**DAC 25/07/23 – 21 PARNELL PLACE NEWCASTLE EAST –
DA2022/00705 – MIXED USE - ALTERATIONS AND ADDITIONS TO
EXISTING HOTEL OR MOTEL ACCOMMODATION (NEWCASTLE
BEACH HOTEL), ANCILLARY FOOD AND DRINK PREMISES AND
COMMERCIAL USE (ANCILLARY HOTEL SPA) AND DUAL
OCCUPANCY (ATTACHED 2 X DWELLINGS)**

PARNELL PLACE

21 Parnell Place, Newcastle East, NSW 2300
LOT 1 /DP815595

DRAWING
 ELEVATION ANALYSIS

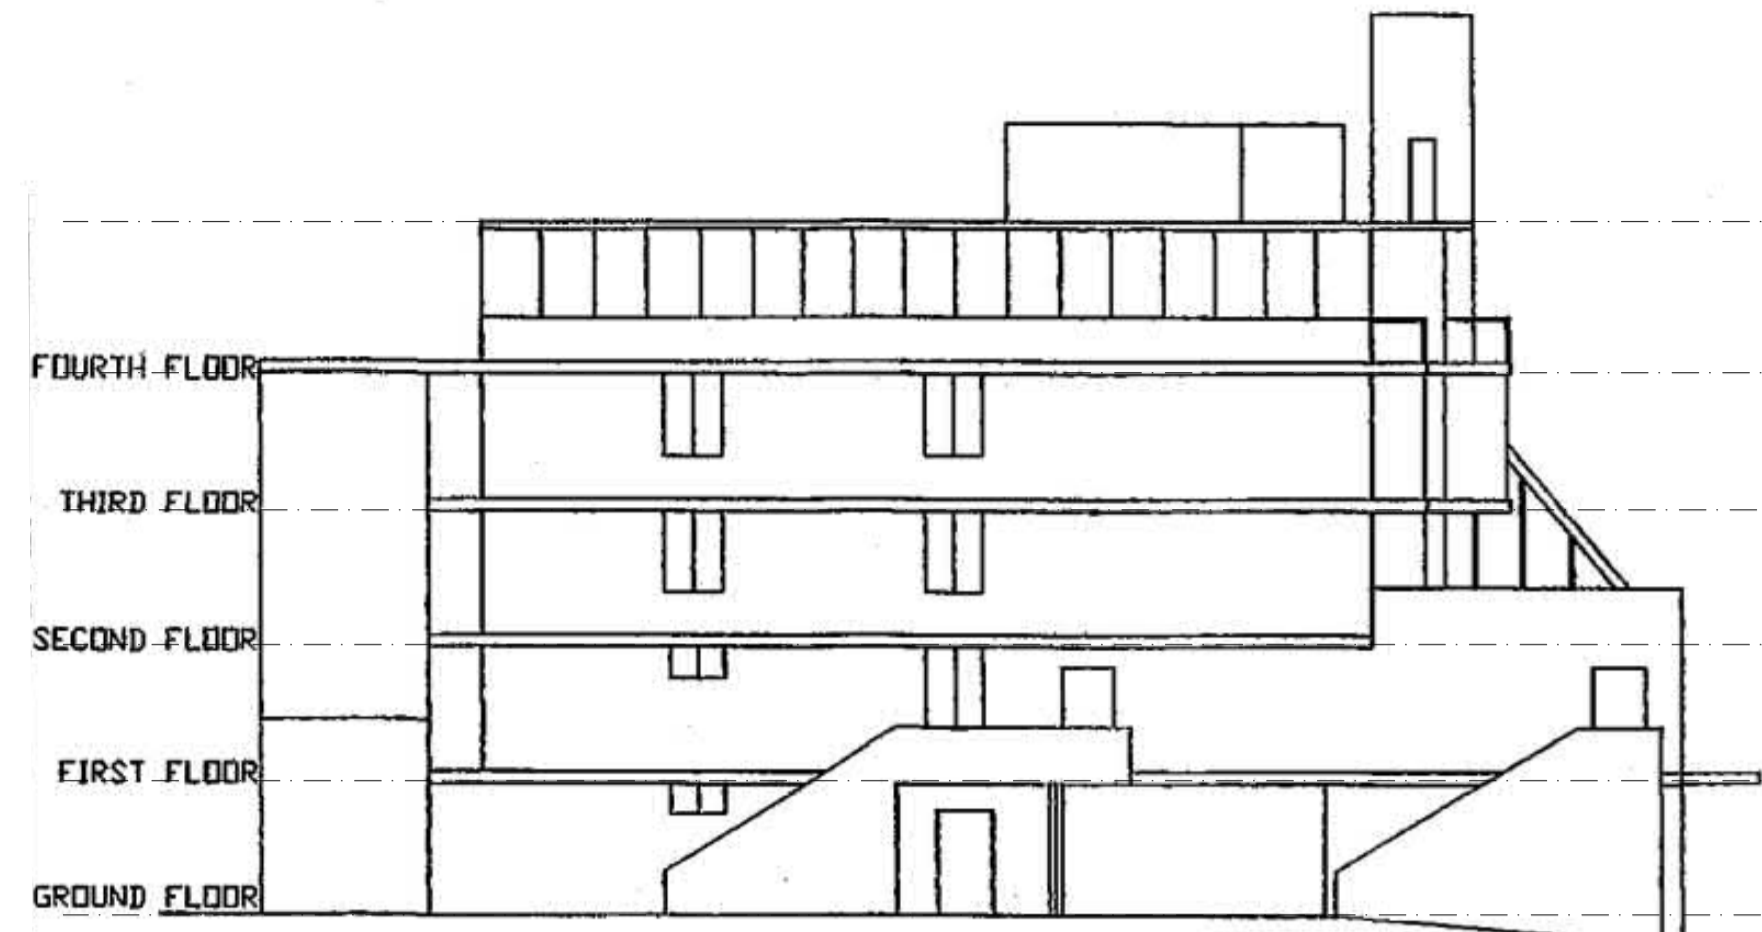
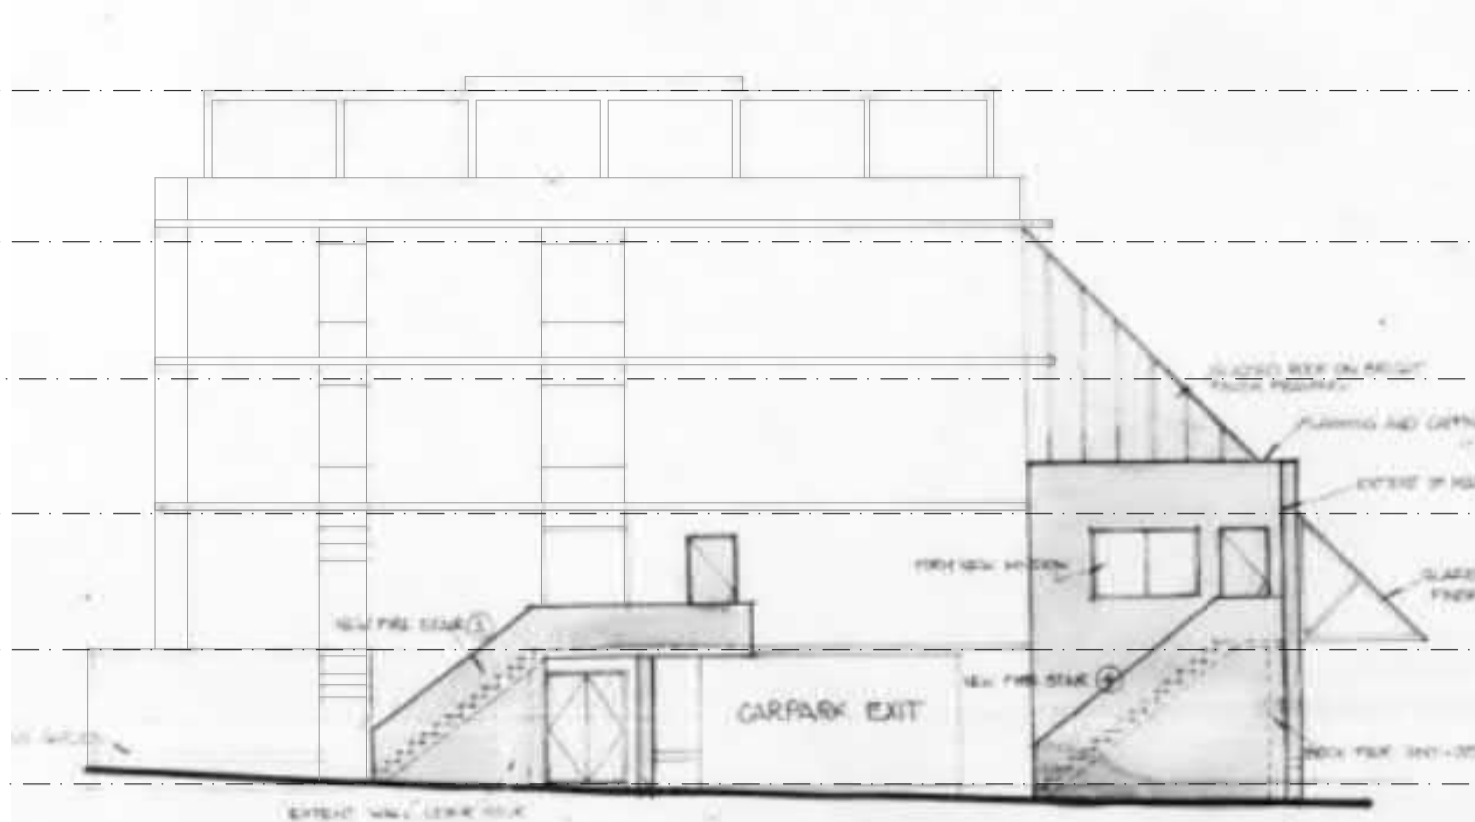
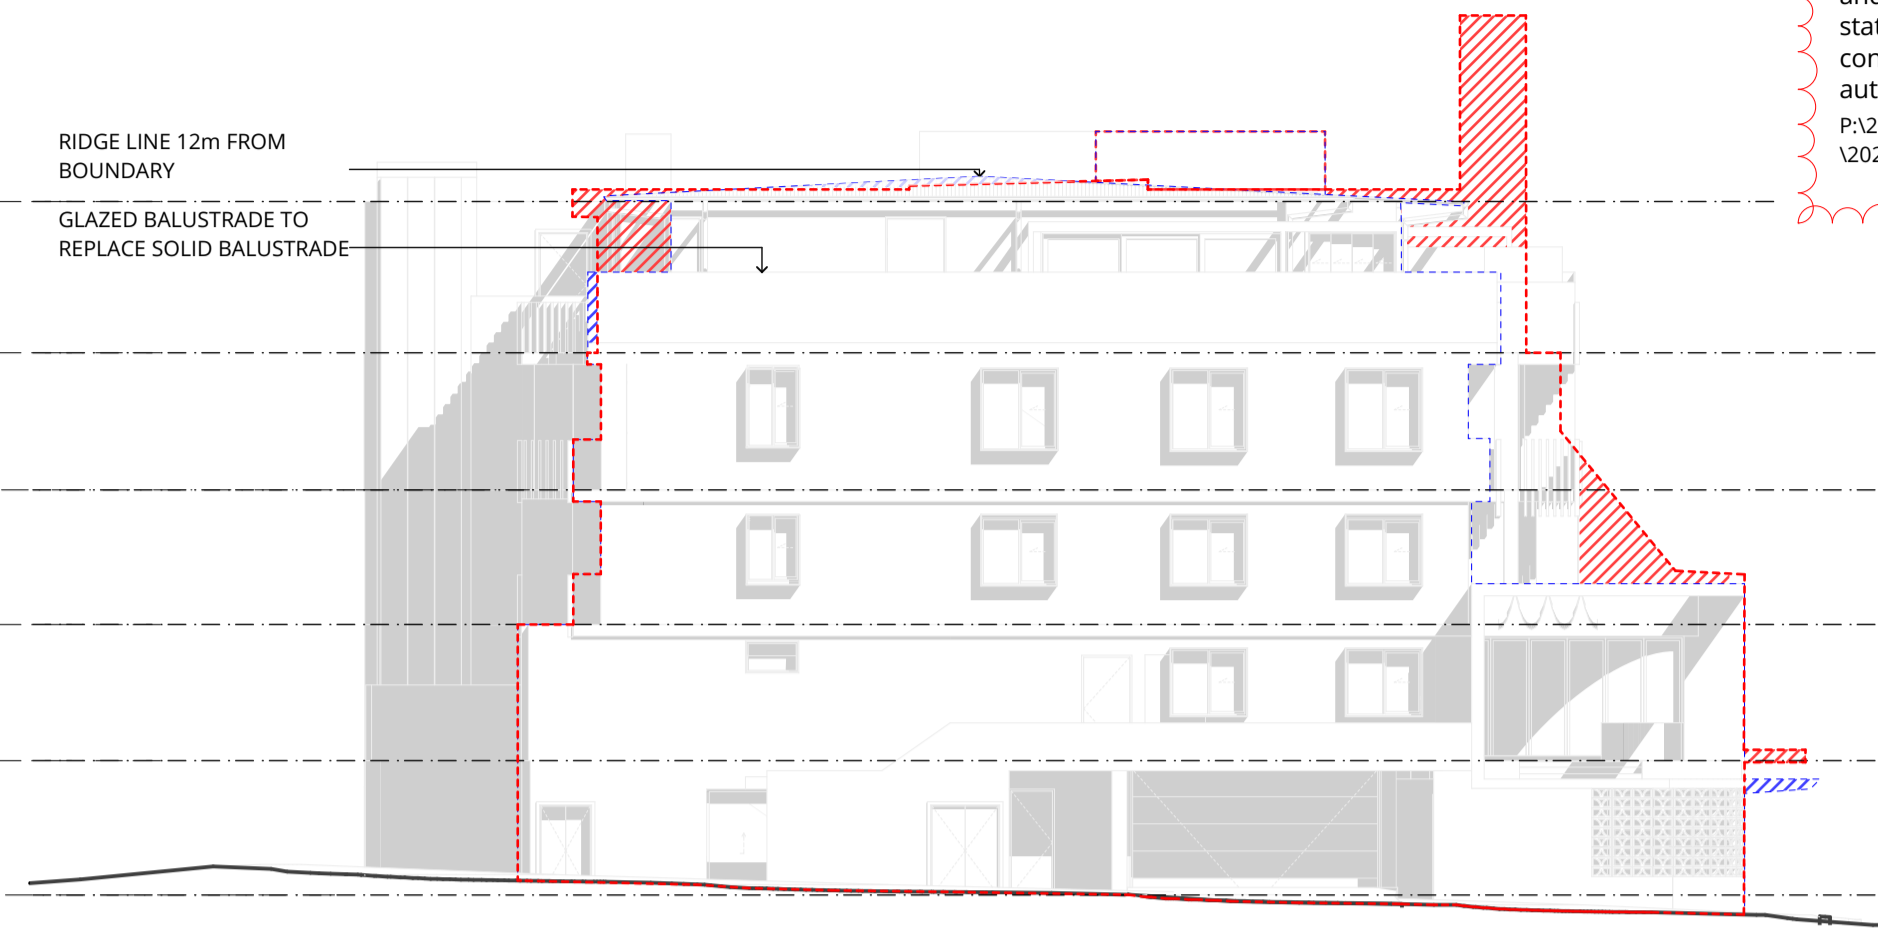
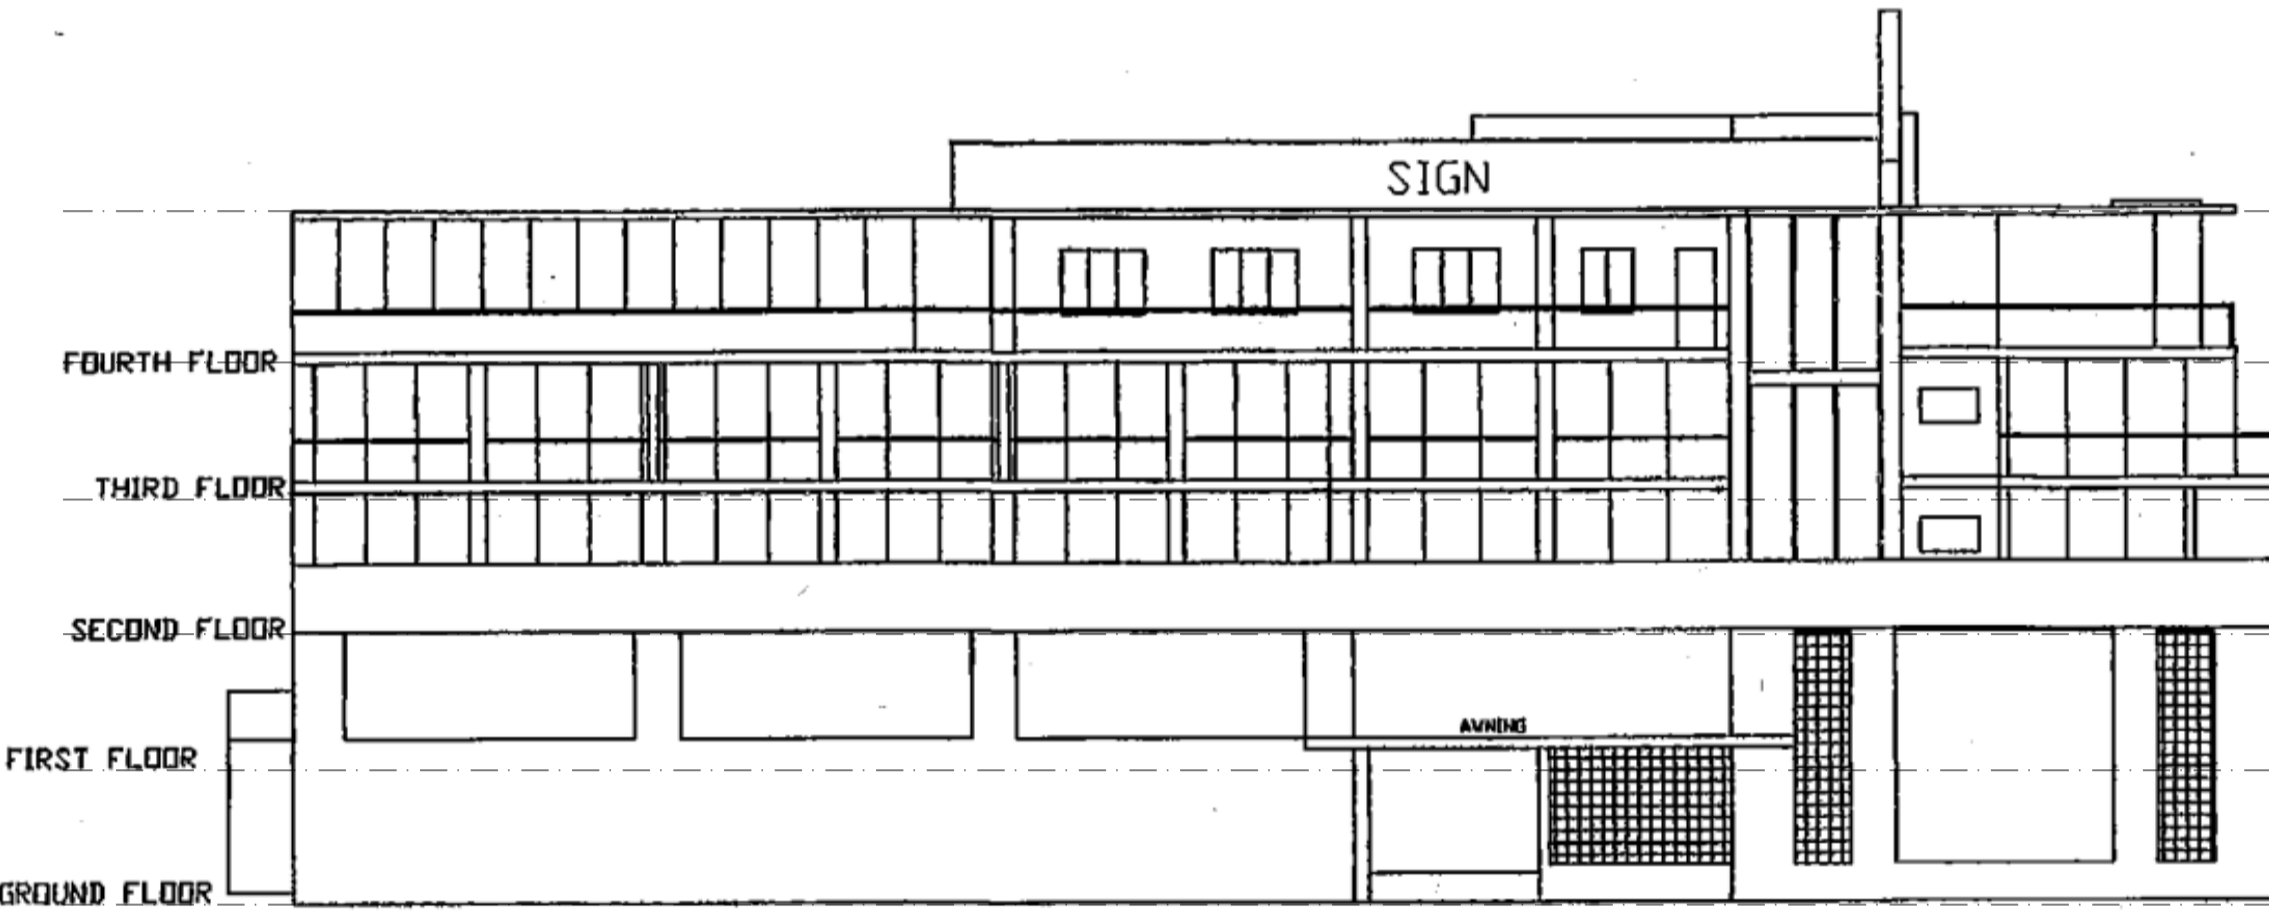
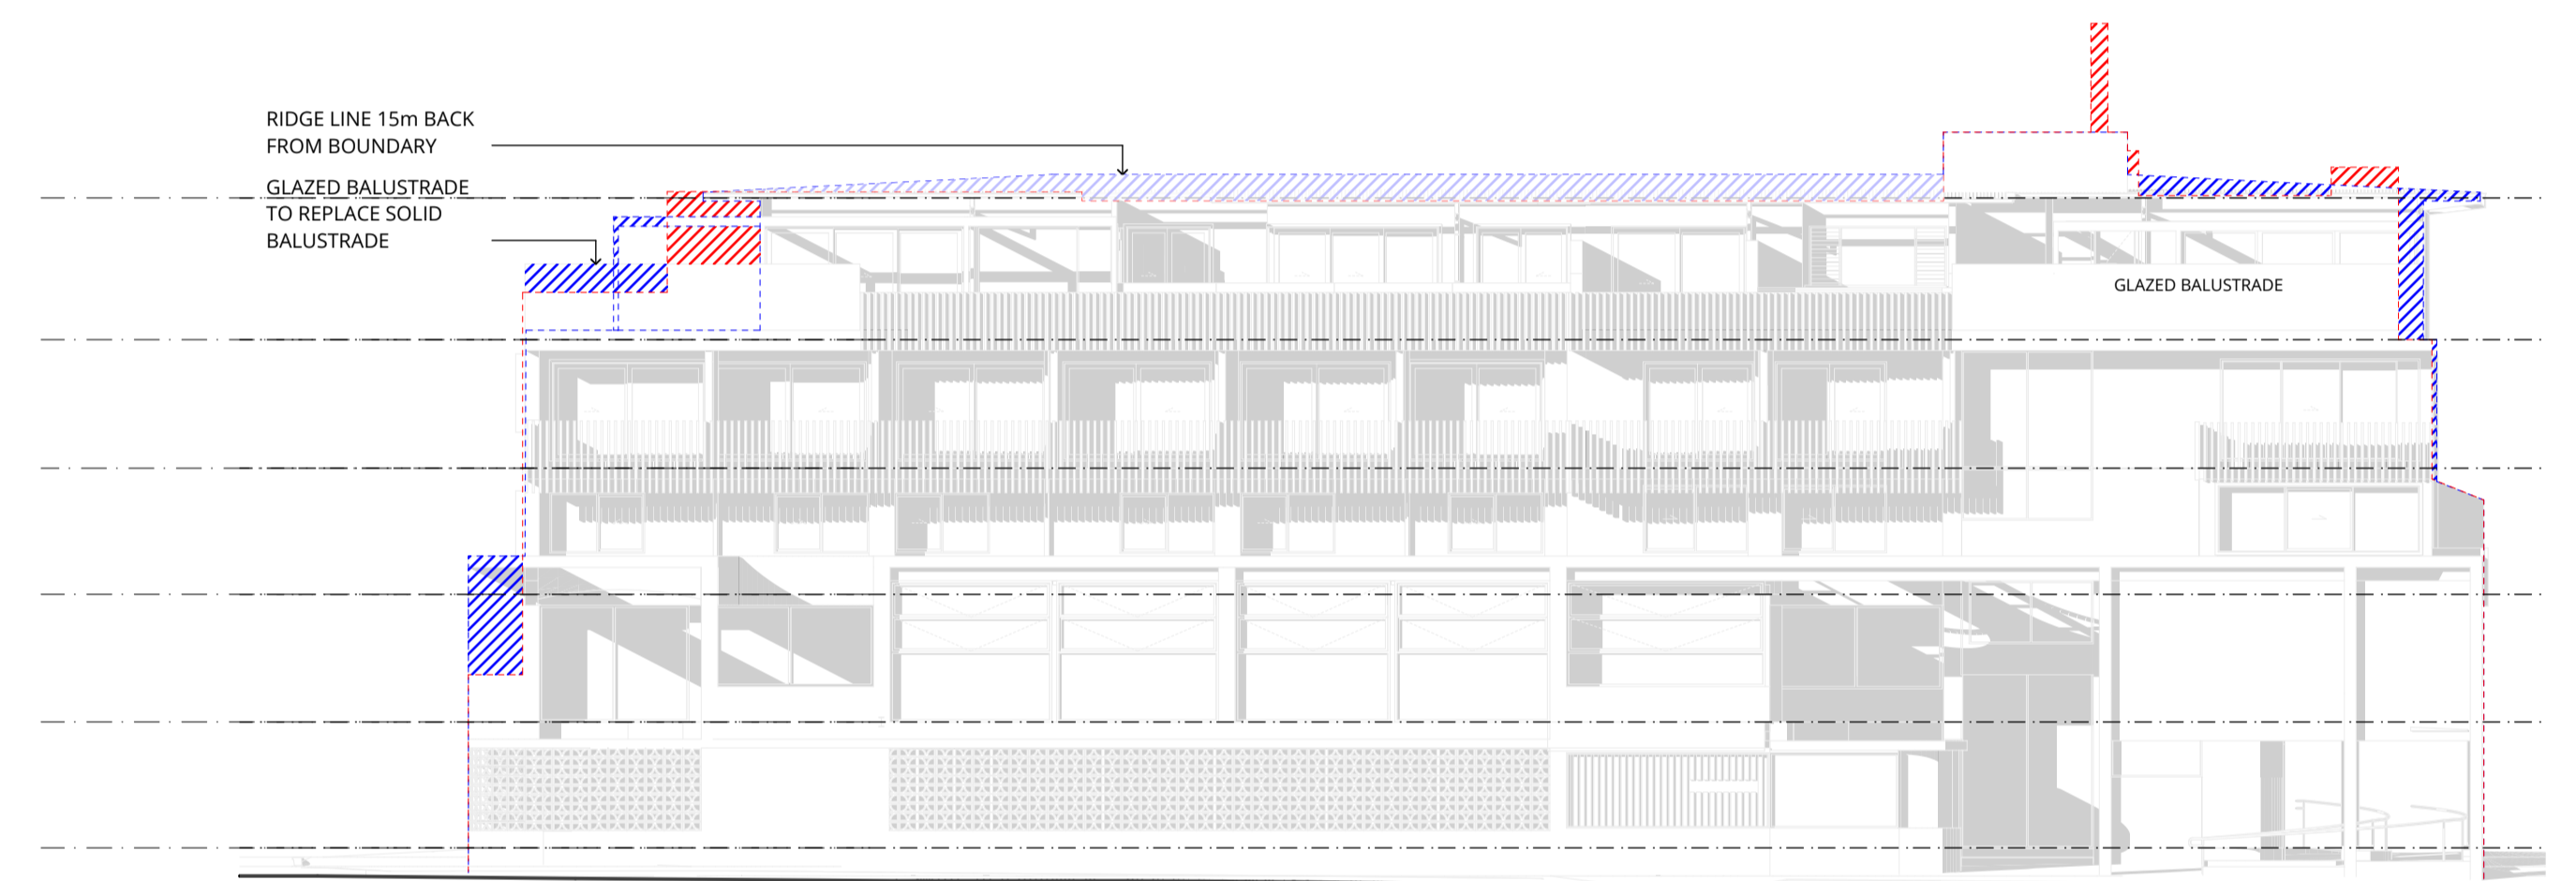
RFI RESPONSE - 13/10/22 & 14/11/22
 - BULK AND SCALE ANALYSIS COMPLETED
 AGAINST EXISTING AND ORIGINAL
 ELEVATIONS

THE EXISTING BUILDING HAS A BALUSTRADE AT LEVEL 4 TO THE WEST WHICH MAINTAINS A SOLID FORM. SINCE WE ARE PROPOSING TO REMOVE THESE SOLID BALUSTRADES AND REPLACE WITH GLASS, WE ARE EFFECTIVELY LOWERING THE DATUM LEVEL AND PERCEIVED BULK
